HISTORIC AND DESIGN REVIEW COMMISSION

Agenda Item No: 26

HDRC CASE NO: 2016-269
ADDRESS: 2044 W HUISACHE AVE
LEGAL DESCRIPTION: NCB 1953 BLK LOT 16
ZONING: R6 H
CITY COUNCIL DIST.: 7
DISTRICT: Monticello Park Historic District
APPLICANT: Dulce Rivera
OWNER: Dulce Rivera
TYPE OF WORK: Addition, door replacement, window fenestration modification
REQUEST:

RIVERA RESIDENCE REMODEL

06 PROPOSED RIGHT ELEVATION
SCALE: 1/8"=1'-0"

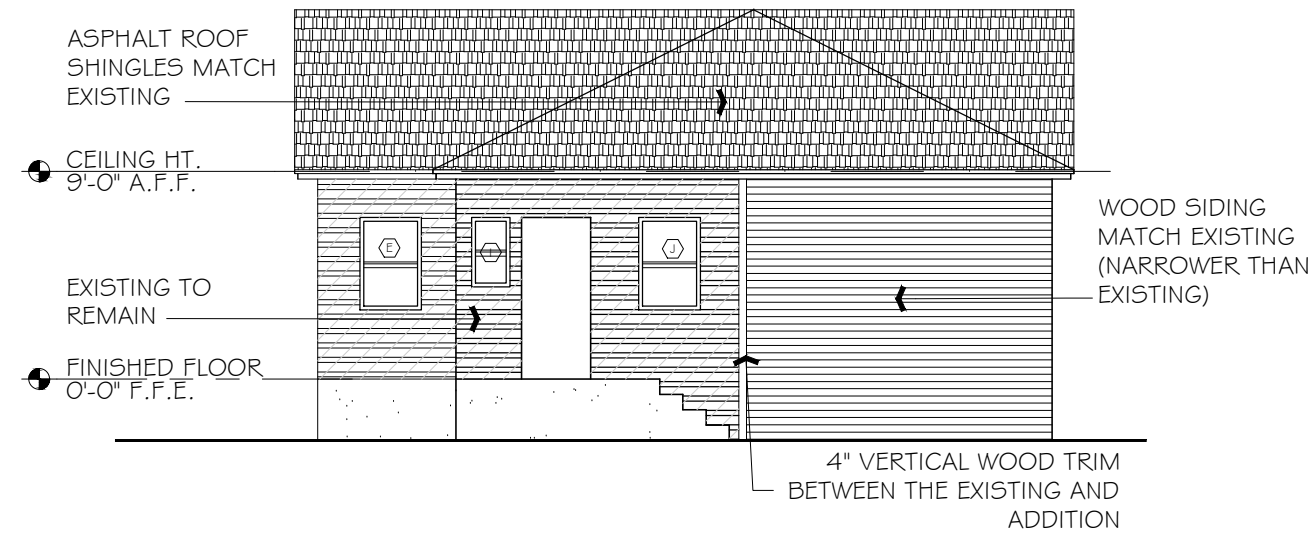
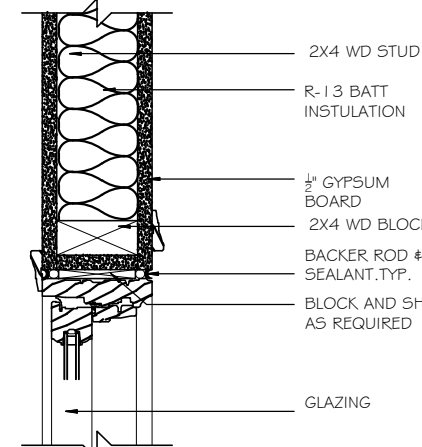
- f. **TRANSITION** – The existing rear foot print has an inset. The applicant is proposing to fill in that inset with the addition. According to the Guidelines for Additions, a transition between the primary historic structure and the addition is needed in order to differentiate the addition from the existing structure. The proposed addition features two 4” vertical trim pieces, indicating the start of the addition. Staff finds this consistent with the Guidelines and recommends the applicant recess the addition from the edges of the historic structure.

- g. **ARCHITECTURAL DETAILS** – The applicant is proposing to remove a square window from the right elevation of the existing structure and install it on the right elevation of the addition. According to the Guidelines for Additions, additions should incorporate architectural details that are in keeping with the architectural style of the original structure. Using the salvaged window proposed is consistent with the Guidelines, however, staff finds it would be more appropriate if the applicant incorporated the existing rear double window where the proposed addition is to be located to be salvaged and used in the addition.

- i. The applicant is proposing to remove a square window from the right elevation of the existing structure and install it on the right elevation of the addition. According to the Guidelines for Exterior Maintenance and Alterations 6.B.i, window openings should be preserved. Staff finds the removal of the windows where the addition to be located appropriate, but finds the removal of square window openings not consistent with the Guidelines. Staff recommends that the existing window opening be preserved and the applicant used the salvaged double window in the addition.

Staff recommends denial of item #3 based on finding i. Staff recommends that the existing side window be retained and the applicant salvage and reuse the existing rear double window in the proposed addition.

03 PROPOSED FLOOR PLAN
SCALE: 3/16"=1'-0"

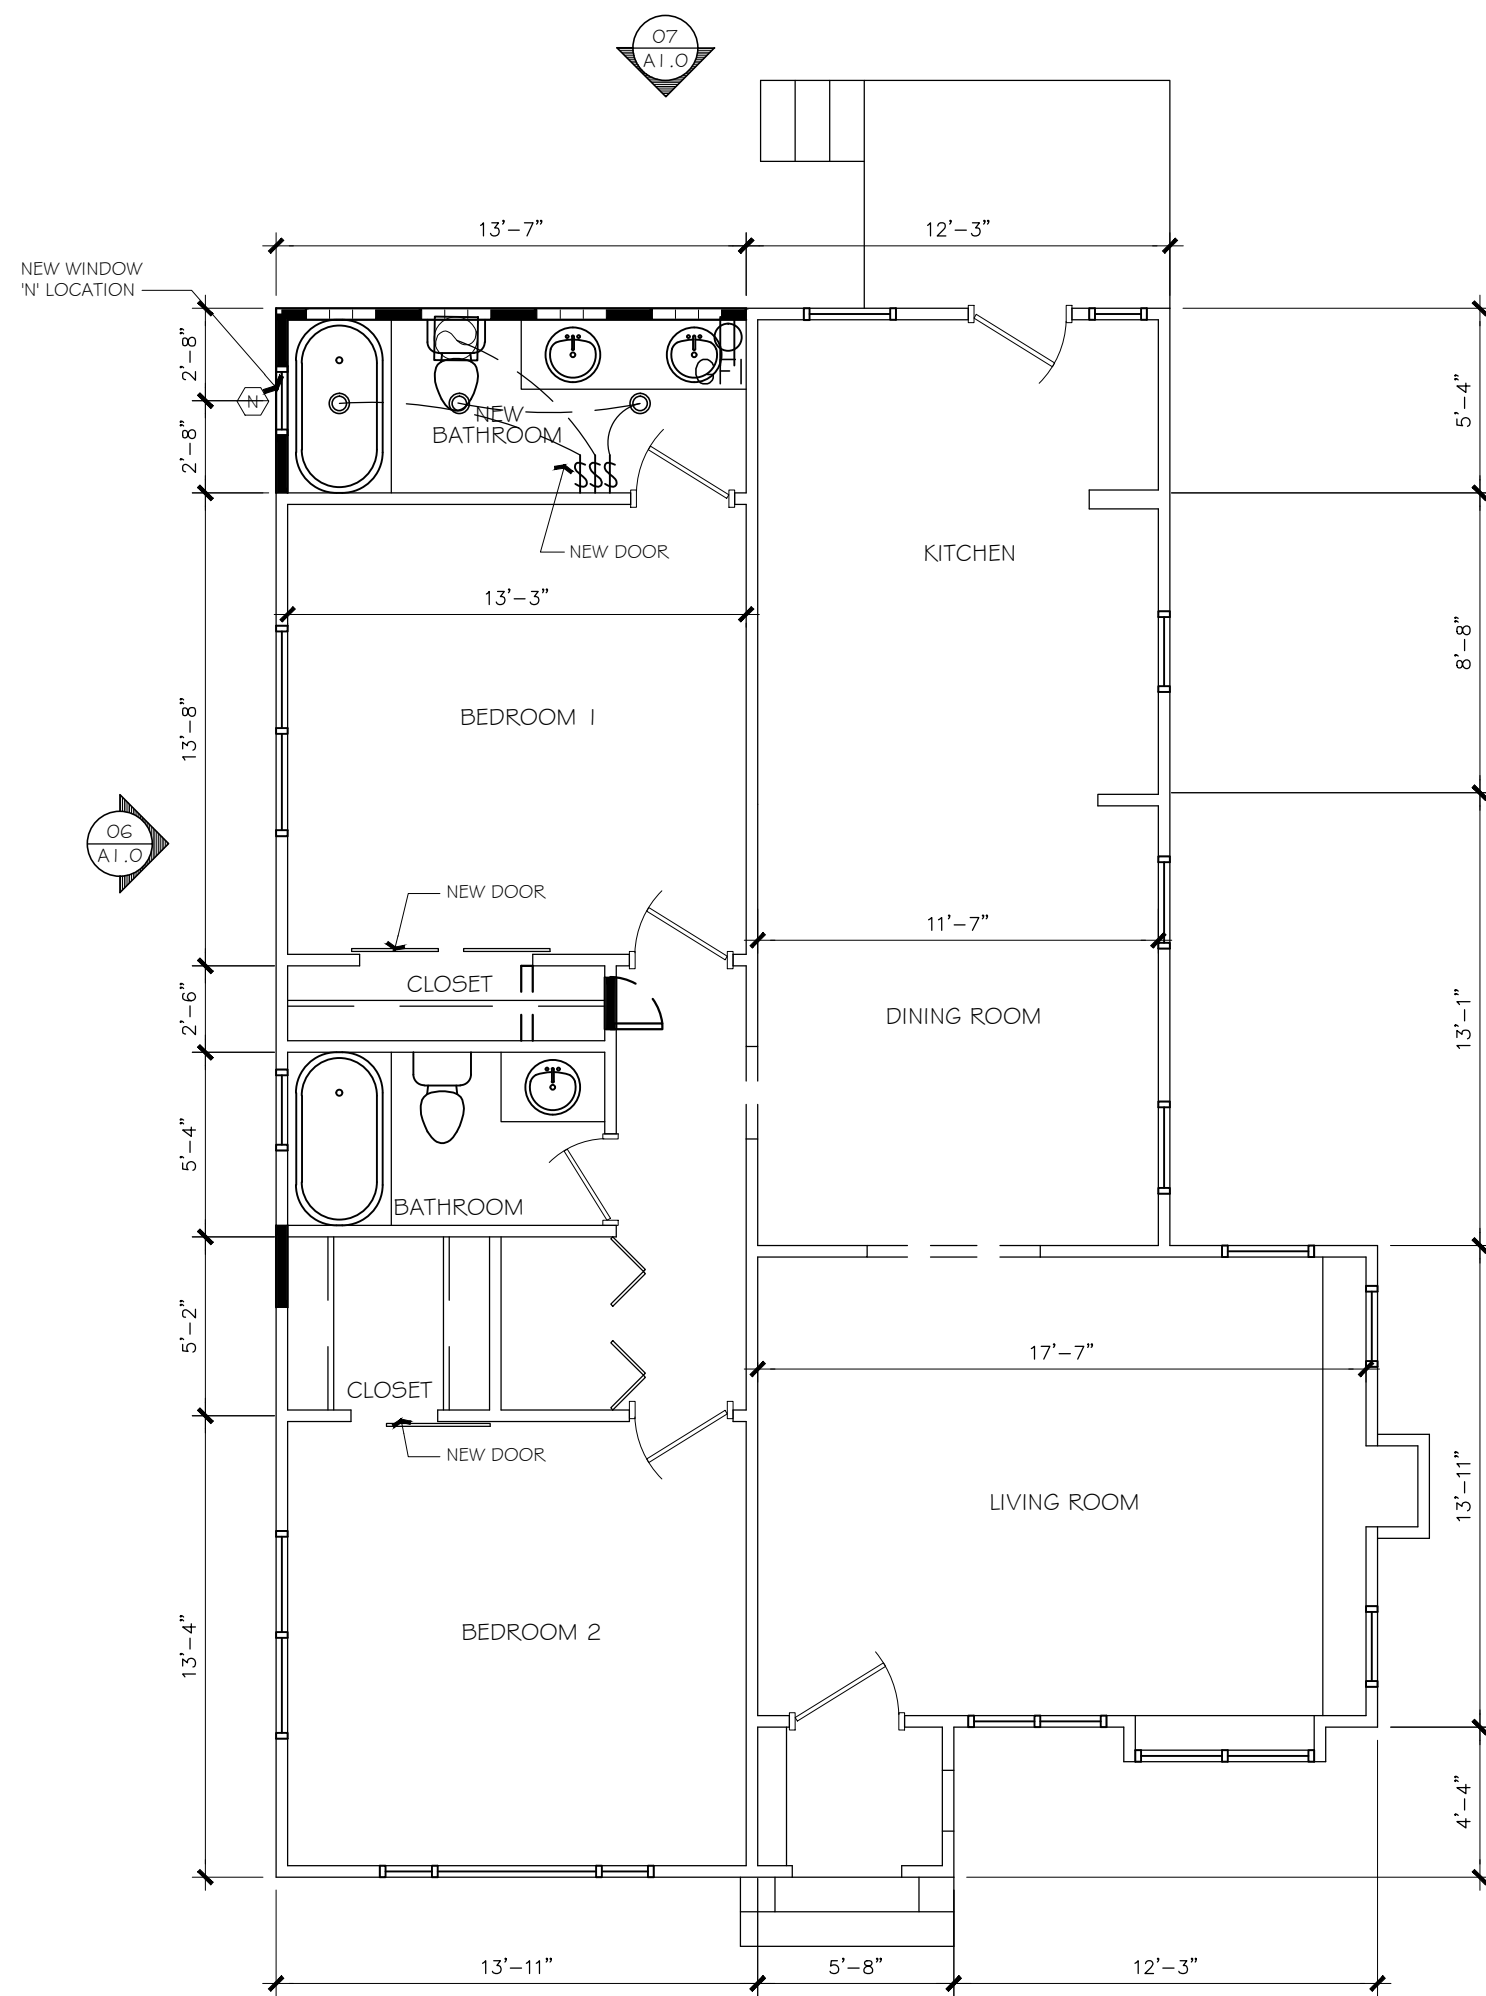
- c. MASSING/SCALE – Existing at the rear of the structure is a hipped roof, double window and a stoop. At the rear of the primary historic structure, the applicant is proposing to construct an addition of 73 square feet with wood siding and a hipped roof. Guidelines for Additions 1.A. states that additions should be sited to minimize visual impact from the public right of way and be subordinate to the historic structure. Staff finds the construction of the addition to the rear and with a hipped roof, which matches the roof form of the existing structure, will not be seen from the public right-of-way.

ReliaBilt French Insulating Core Blinds Between The Glass Full Lite Left-Hand Inswing Primed White Steel Prehung Entry Door (Common: 36-in x 80-in; Actual: 37.5-in x 81.75-in)

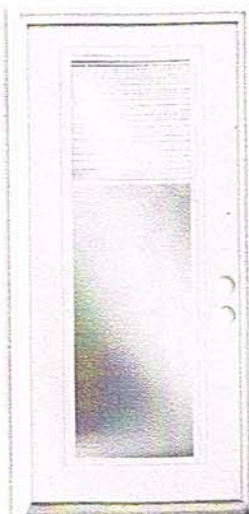
- h. The existing rear door is a non-original solid wood door. The applicant is proposing to replace it with a steel door with a full window light and insulated core blinds between the glass. According to the Guidelines for Exterior Maintenance and Alterations 6.B., non-historic windows should be replaced with those that are typical for the architectural style. Staff finds the steel door proposed is not consistent with the Guidelines. Staff recommends the door be made of wood.

Staff recommends approval of items #1 and #2 based on findings a through h with the stipulation that the rear door be made of wood.
